Village of Lemont
Planning and Zoning Commission

PLANNING & ZONING COMMISSION
Regular Meeting
Wednesday, July 20, 2016
6:30 p.m.

TO: Planning & Zoning Commission
FROM: Heather Valone, Village Planner
THRU: Charity Jones, AICP, Planning & Economic Development Director
SUBJECT: Case 16-05 23 E Logan St. Variation
DATE: July 8, 2016

TO: Planning & Zoning Commission
FROM: Heather Valone, Village Planner
THRU: Charity Jones, AICP, Planning & Economic Development Director
SUBJECT: Case 16-06 13769 Main St. Special Use and Variation
DATE: July 8, 2016

Figure 4 the asphalt edge the neighboring property constructed directs stormwater from the July 7, 2016 rain event towards the subject property.

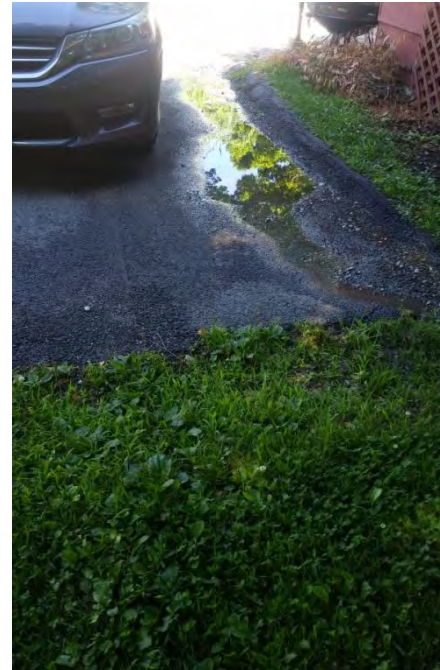
The property was visited by staff the morning after a large rain event on July 8, 2016 Figures 2 and 3 show that there was little to no pooling of water in the rear yards of the subject property or on the neighboring property to the north. The only pooling water observed was in a portion of the alley to the west of the subject property where a neighbor constructed an asphalt edge because their property naturally sits lower than the surrounding properties. The edge contained the water to the alley portion only as shown in Figure 4.

TOPOGRAPHICAL SURVEY & SITE DEVELOPMENT PLAN

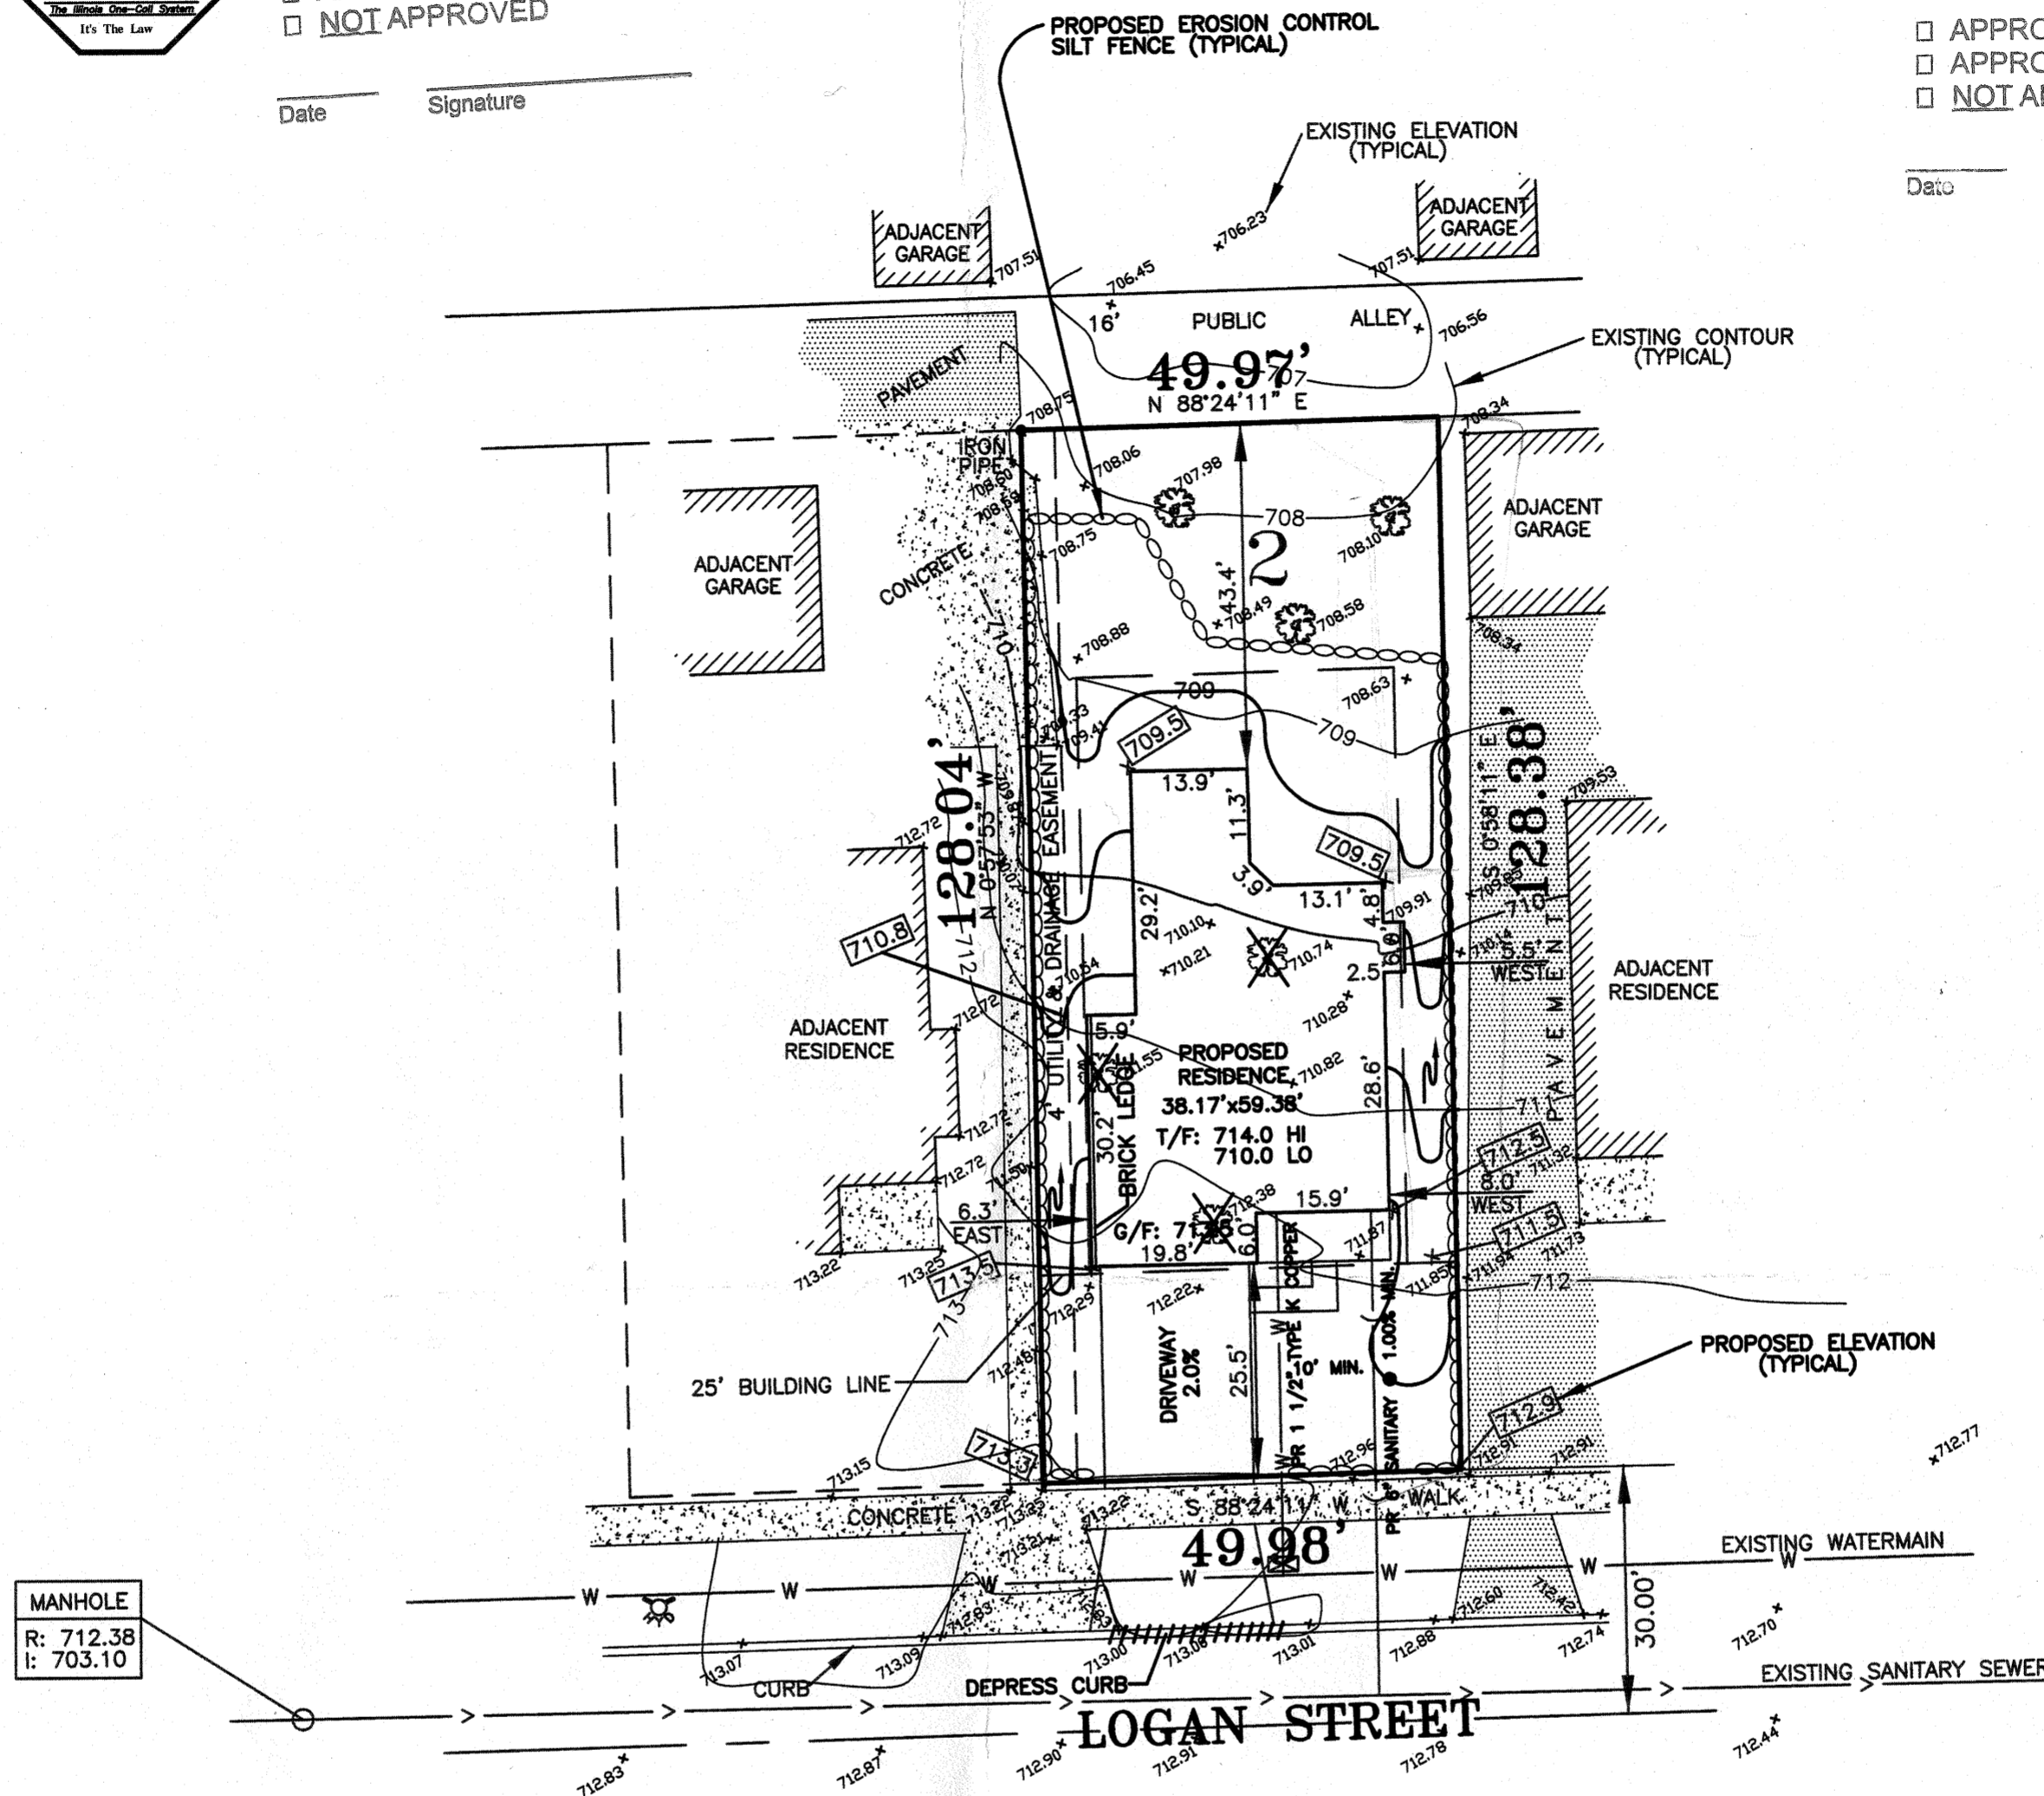
The applicant submitted a building permit for a single-family home with a two-car attached garage accessing off E Logan St. on April 14, 2016. Staff denied the permit on April 19, 2016 because of the alley access requirement. The permit had multiple items in addition to the driveway access which did not meet UDO standards including the proposed maximum square footage of the home. The applicant filed the appeal May 14, 2016. The PZC denied the appeal on June 15, 2016 finding that the alley does provide access to the subject property.

Additionally, the proposed variation request could create the basis of another variation application. The proposed home as it is currently depicted in the submitted architectural plans exceeds the maximum permitted square footage for R-4A homes. The R-4A properties are limited in size to conform to the existing homes. The maximum square footage a home that can be built on the subject property is 2,626.43 s.f. The proposed home with the attached two-car garage exceeds the maximum area by 192.93 s.f. The removal of the attached garage would reduce the home area, by 189.98 s.f. The proposed driveway and garage are not consistent with the neighborhood characterizes or the R-4A standards; granting the variation may trigger the applicant to request another variation from the UDO maximum home size restrictions to allow the building to be constructed as currently shown in the architectural plans.

Detailed Alternative Site Design: Without Variation

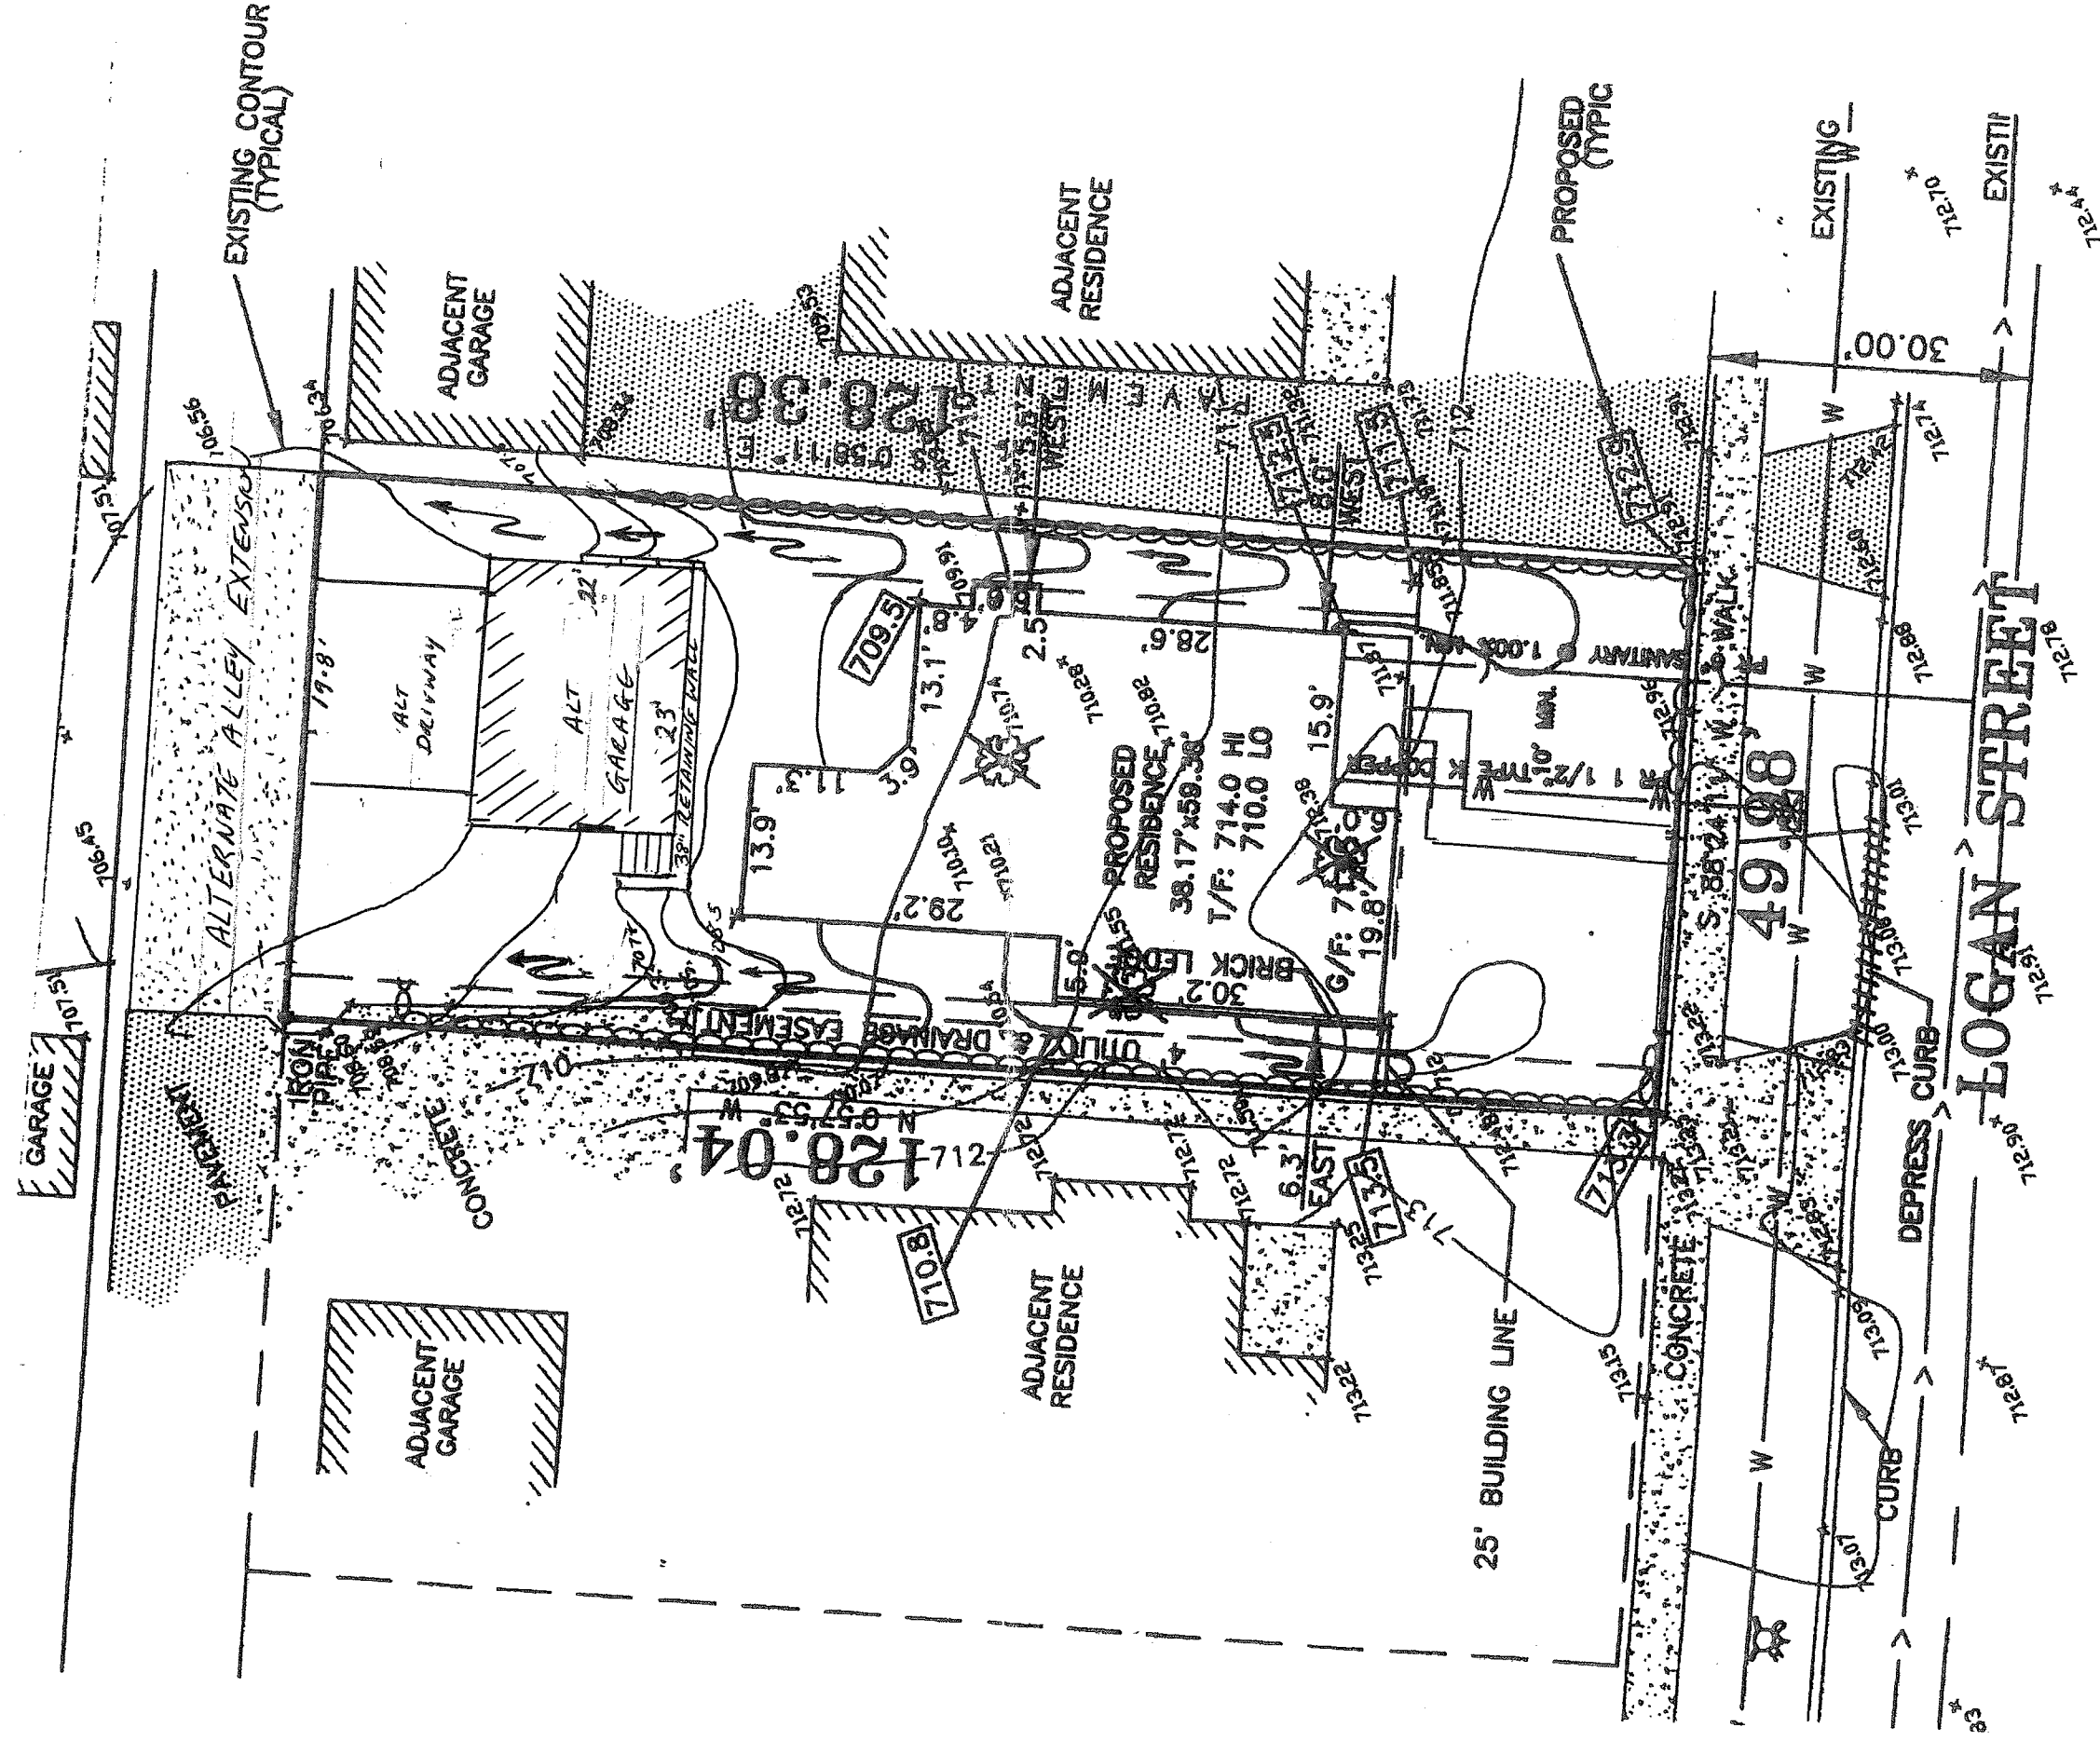
the north (rear). Though the alley extension represents an increase in impervious area, it is not a significant increase to create stormwater issues since the property to the north is already lower and accepting a portion subject property's runoff. The home on the northwest side of the alley constructed an asphalt edge that interrupts the stormwater and directs the stormwater to the grass area behind the subject property. This berm was likely intentionally created by the neighbor to direct more stormwater to the subject property as the site has been vacant for years. The Village Engineer's full comments are attached.
